Eagle Quarter II, Newbury

Response to Active Travel England Comments

Document Reference: WIE18916-114.R.1.2.3 ATE

23/02094/FULMAJ: Full planning permission for the redevelopment of the Kennet Centre comprising the partial demolition of the existing building on site and the development of new residential dwellings (Use Class C3) and residents' ancillary facilities; commercial, business and service floorspace including office (Class E (a, b, c, d, e, f, and g)); access, parking, and cycle parking; landscaping and open space; sustainable energy installations; associated works, and alterations to the retained Vue Cinema and multi storey car park.

Photograph 1 – Market Street Pedestrian Crossing

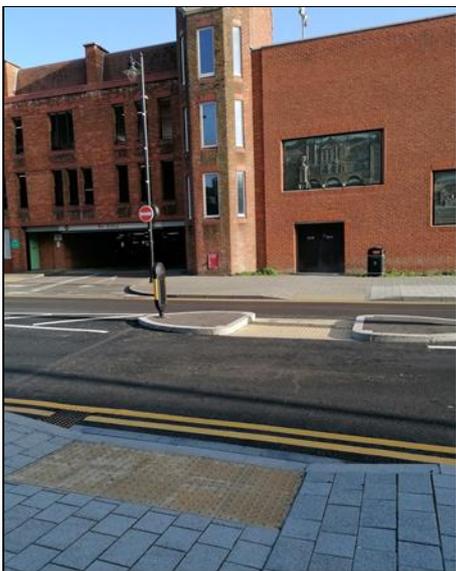
Again, the applicant has not directly addressed ATEs comments regarding this point. It is however noted that Paragraph 12 of the Local Highway Authority response sought consideration on this point. The applicant has noted that there is an 'existing pedestrian crossing to the east of the MSCP on Market Street that includes tactile paving and a central refuge.'

It is recognised that the applicant has committed to further discussions with the Highway Authority regarding the most suitable form of crossing at this point. While it is anticipated that these discussions will result in a positive improvement to the existing situation in a way that benefits walking, wheeling and cycling, ATE seeks confirmation from the LPA that the outcome of these discussions will secure by condition / obligation an improvement to the existing situation. ATE is of course willing to provide input to these discussions as necessary.

The existing pedestrian crossing to the east of the MSCP on Market Street includes tactile paving and a central refuge, as illustrated in Photograph 1 below. This crossing was reinstated to suit the new footway alignment which formed part of the Market Street S278 works.

We consider the existing crossing to be more than adequate for the speed and volume of traffic on Market Street. No amendments to this existing crossing are proposed.
